**SUBJECT: NEW VEHICLE DEMONSTRATION / DELIVERY HOLD -
 Safety Recall 22S66**

Certain 2022 Model Year Bronco Sport Vehicles
 Fuel Tank Replacement

**NEW VEHICLE DEMONSTRATION / DELIVERY HOLD -
Safety Recall 22S66**
Certain 2022 Model Year Bronco Sport Vehicles
Fuel Tank Replacement

FIGURE 1

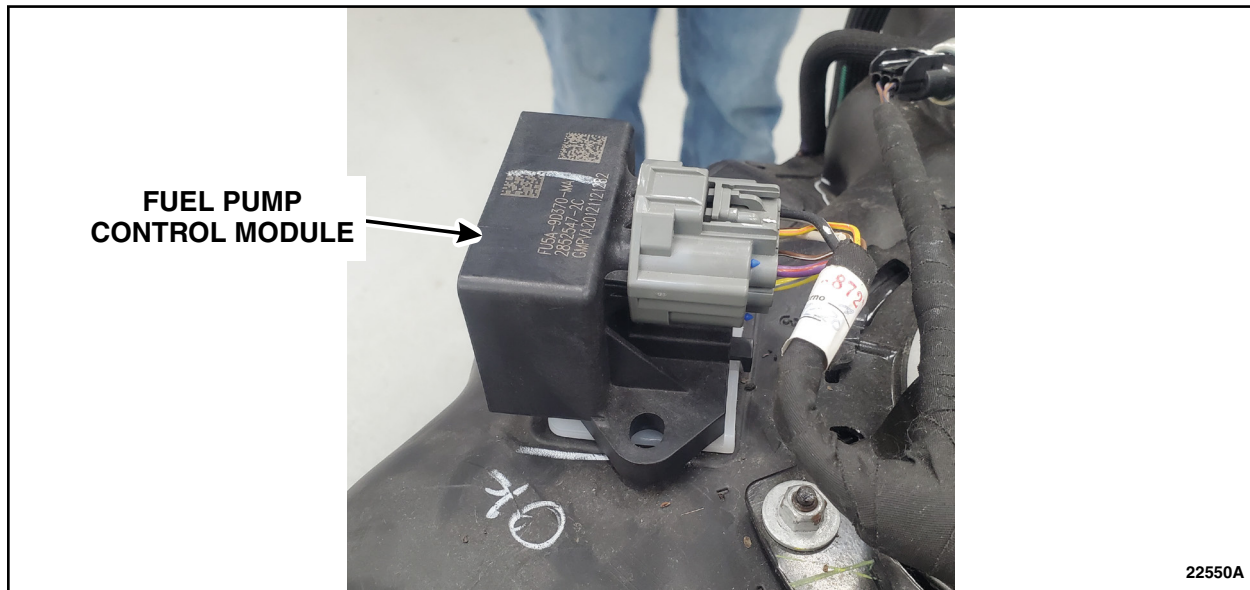
1. Remove the fuel tank. Please follow Workshop Manual (WSM) Procedures in Section 310-01A for 1.5L engines and Section 310-01B for 2.0L engines.
2. Locate the fuel pump control module (FPCM). See Figure 1.

3. Inspect the FPCM. Is the fuel pump control module detached from or hanging off of the fuel tank?
 - Yes – Does not pass inspection. Proceed to step 4.
 - No – Passes inspection. Proceed to step 5.
4. Inspect the FPCM and the electrical connector for possible damage. Is there any damage present?
 - Yes – Does not pass inspection. Contact the SSSC for further repair instructions, then proceed to step 5.
 - No – Passes inspection. Proceed to step 5.
5. Remove and transfer the FPCM, hose, and straps underneath the tank to the *new* fuel tank.
6. Install the fuel pump and sender unit into the *new* fuel tank. Please follow WSM Procedures in Section 310-01A for 1.5L engines and Section 310-01B for 2.0L engines.
7. Install the *new* fuel tank. Please follow WSM Procedures in Section 310-01A for 1.5L engines and Section 310-01B for 2.0L engines.
